**Title: Stage 1 Road Safety Audit and Quality Audit,
For;
Proposed Residential Development at, Grace Park Court,
Beaumont Road, Dublin 9.**

**Client: Waterman Moylan Consulting Engineers on behalf of Urban
Life.**

Report reference: 2966R02

Drawing PRD-WMC-ZZ-XX-DR-C-P2020, Rev - , Southern access.

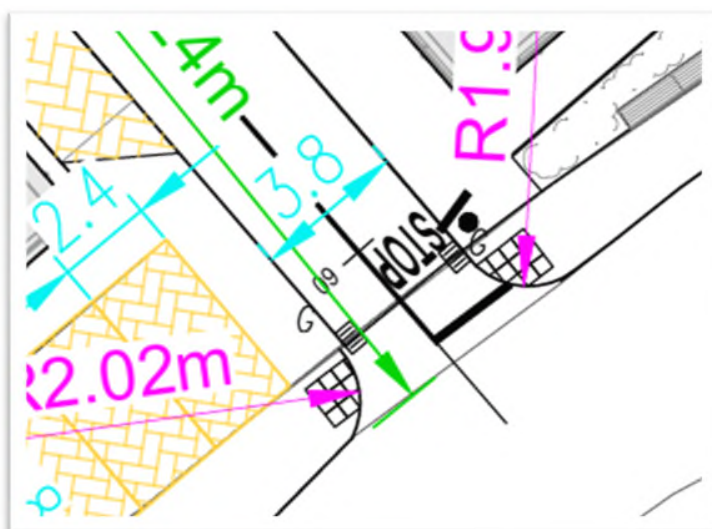
There is no pedestrian route at the southern access. Pedestrians will have to share space with vehicles which could lead to collisions.

It is recommended that a footpath be provided or that the street be changed to a shared use street with all the features expected of one including a pedestrian refuge area.

Drawing PRD-WMC-ZZ-XX-DR-C-P2020, Rev - Internal footpath southern block.

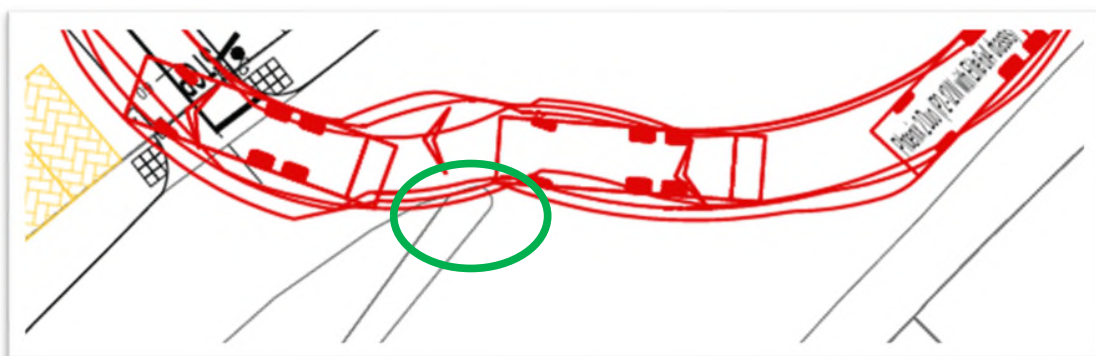
There will be limited inter-visibility between exiting drivers and pedestrians entering the carriageway at the front of the southern block. This could lead to collisions.

It is recommended that adequate inter-visibility be provided.

Drawing PRD-WMC-ZZ-XX-DR-C-P2052, Rev -, Swept path for refuse vehicle.

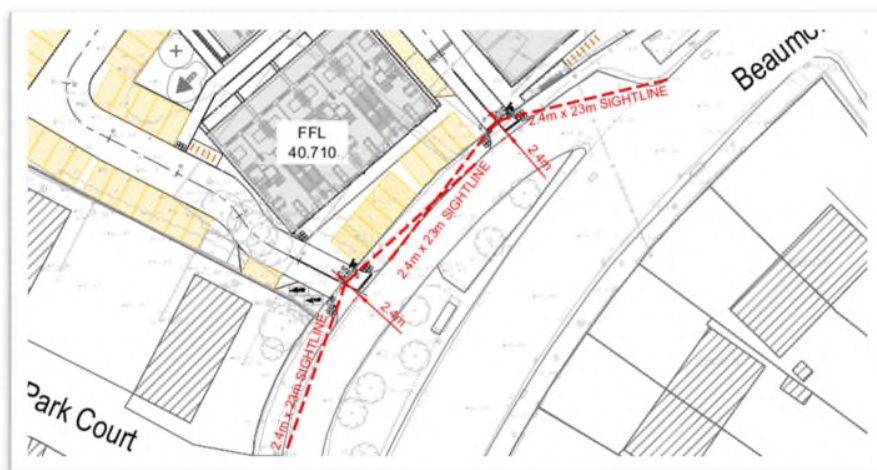
The swept path shows that a refuse vehicle may strike the utility pole at the access to Grace Park Court Loop from Beaumont Road. This could lead to material damage of the utility pole.

It is recommended that the layout be modified to ensure there is a clear gap between the utility pole and the overhang of the swept path.

PRD-WMC-ZZ-XX-DR-C-P2020, perpendicular parking space.

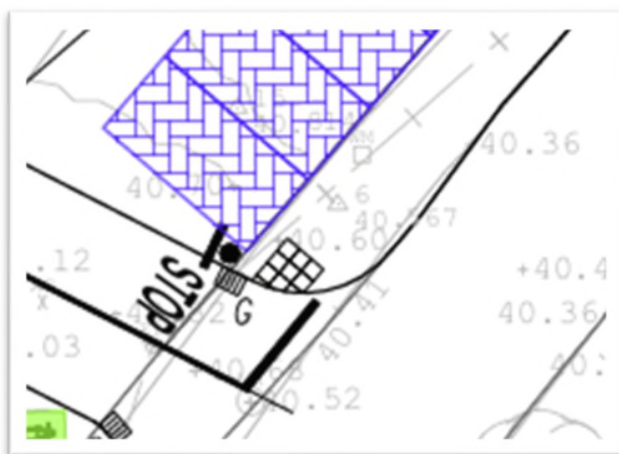
Access to the last perpendicular parking space will be across the tactile paving and very close to the stop sign. This will be a hazard for pedestrians crossing the access.
